April 27, 2000  
IPN-00-033

Subject: **Indian Point 3 Nuclear Power Plant**  
**Docket No. 50-286**  
**Proposed Technical Specification Changes Associated With**  
**Pressure-Temperature and Overpressure Protection System**  
**Limits for Up To 16.2 Effective Full Power Years**

**PROPOSED REVISIONS TO TECHNICAL SPECIFICATION CHANGES ASSOCIATED  
WITH PRESSURE-TEMPERATURE AND OVERPRESSURE PROTECTION SYSTEM  
LIMITS FOR UP TO 16.2 EFFECTIVE FULL POWER YEARS**

FIGURE 4.3-1

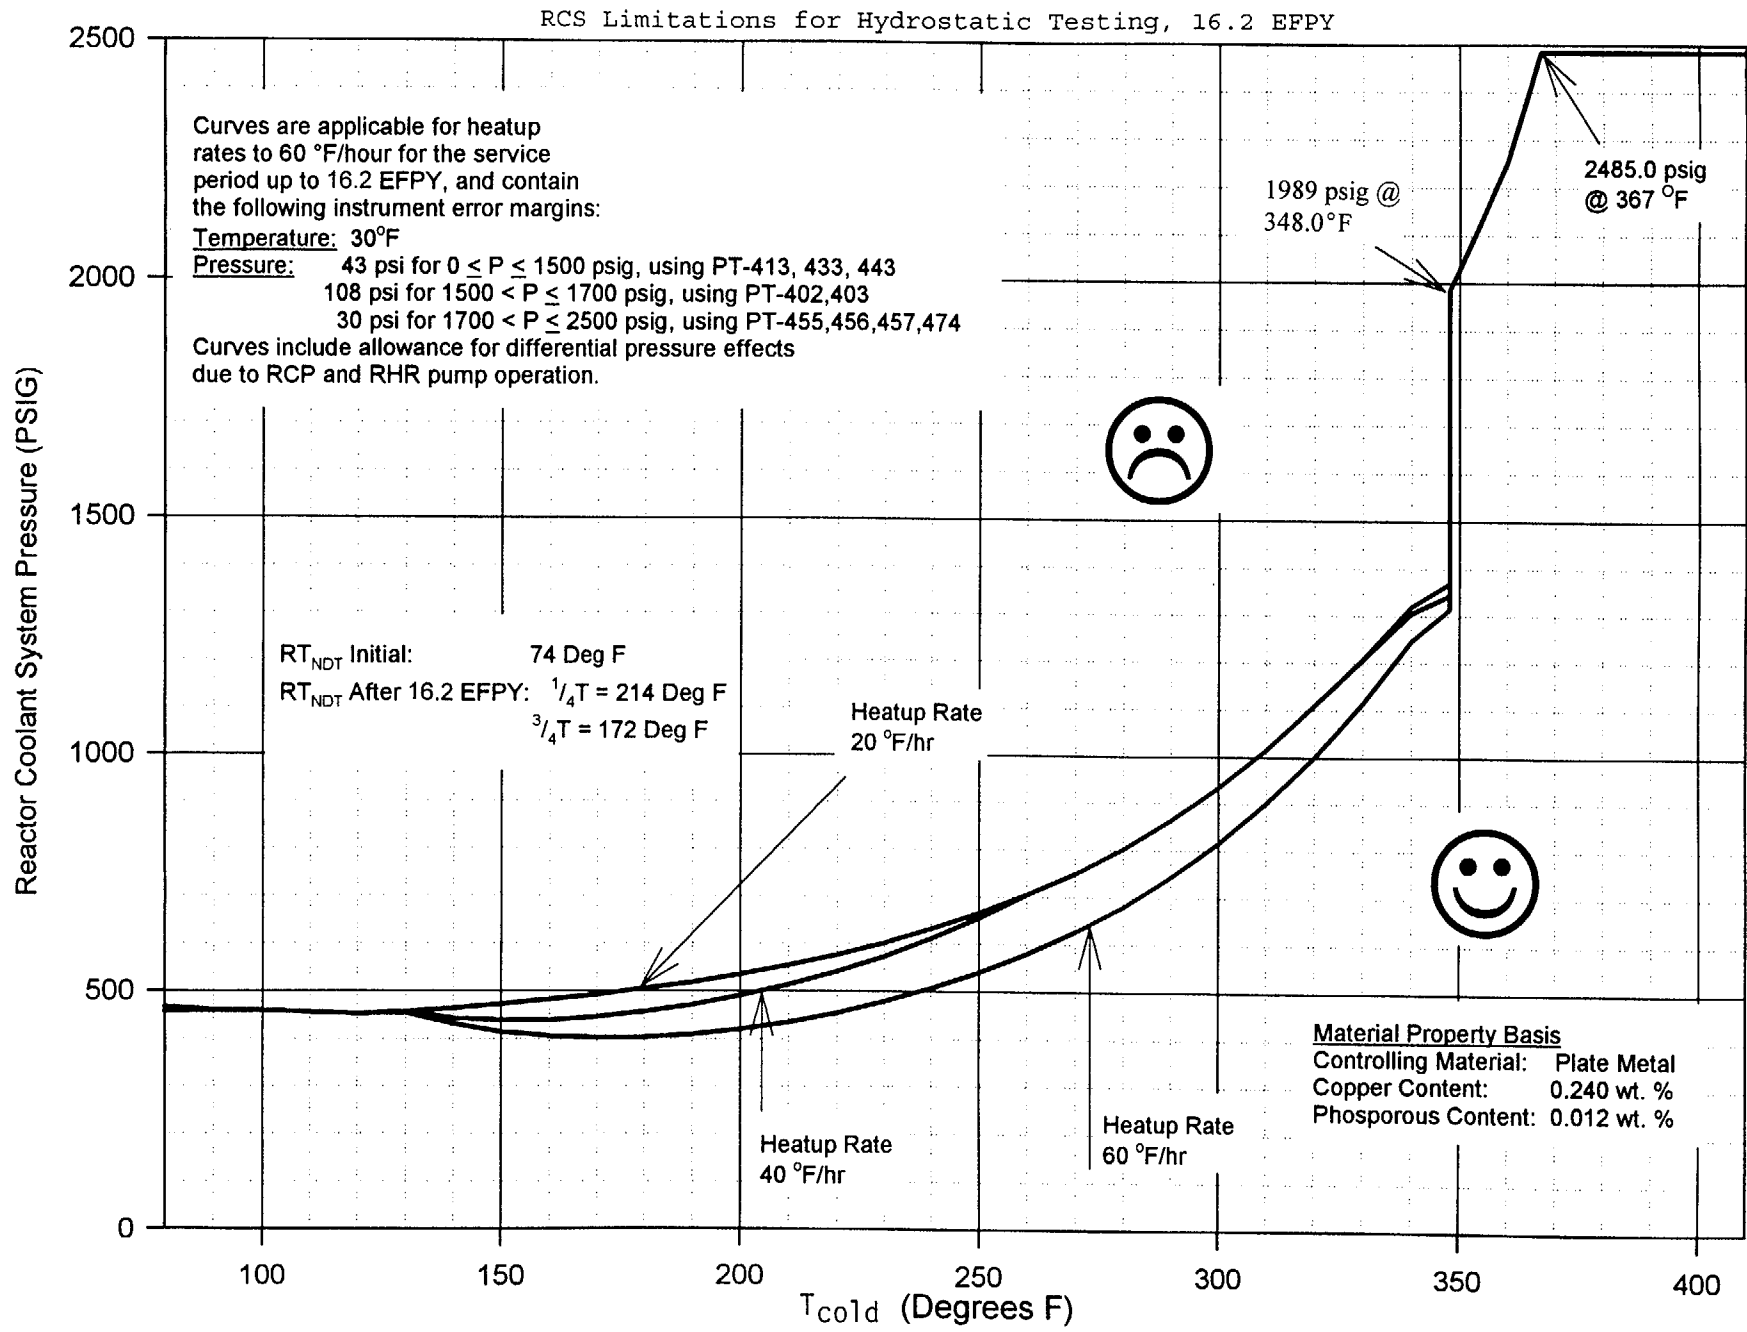
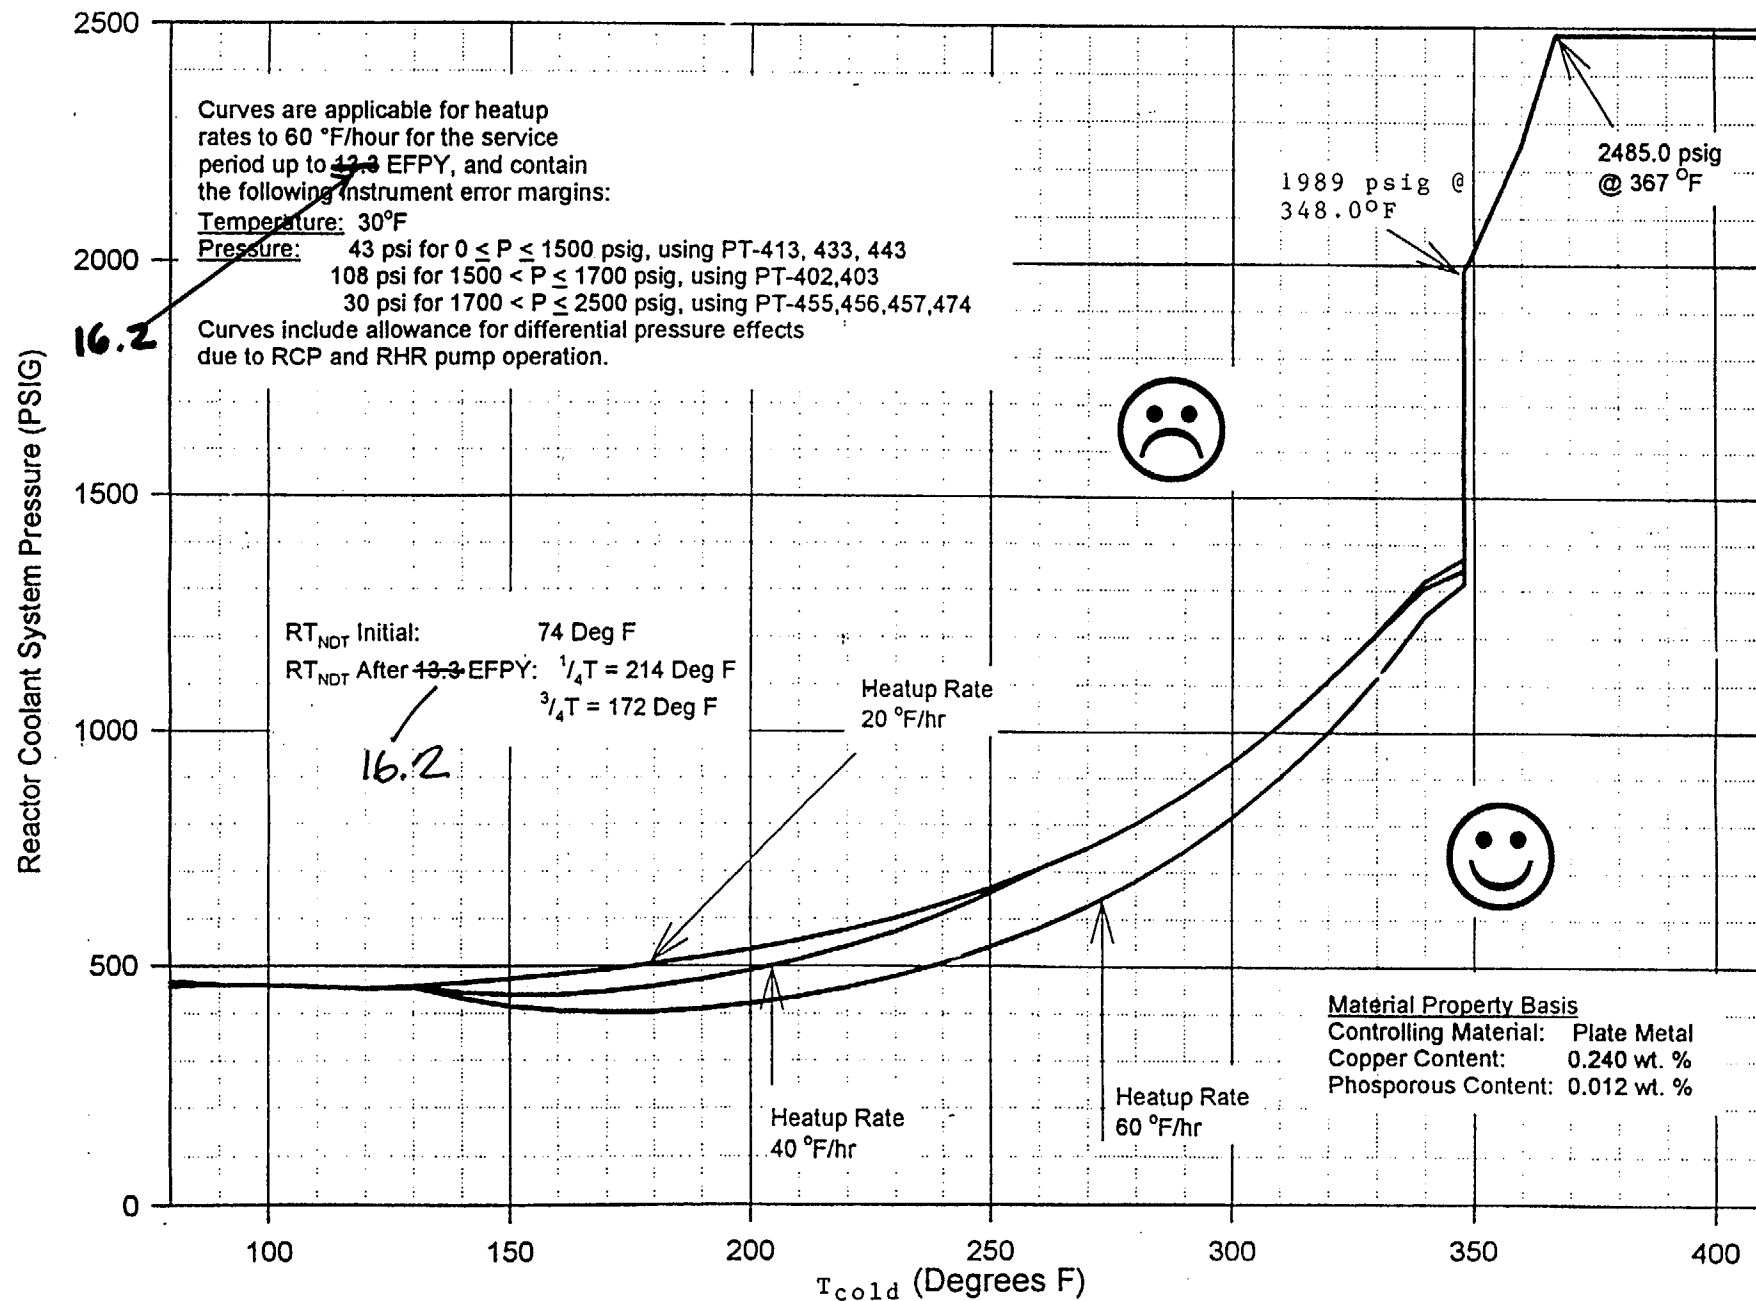
Replace:

"The Reactor Coolant System leak test temperature-pressure relationship shall be in accordance with the limits of Figure 4.3-1 for heatup for the first 13.3 EFPYs of operations."

12. **Figure 4.3-1**

Replace current figure title with:

RCS Limitations for Hydrostatic Testing, ~~12.3 EFY~~ **16.2 EFY**

"The Reactor Coolant System leak test temperature-pressure relationship shall be in accordance with the limits of Figure 4.3-1 for heatup for the first 16.2 EFPYs of operations."
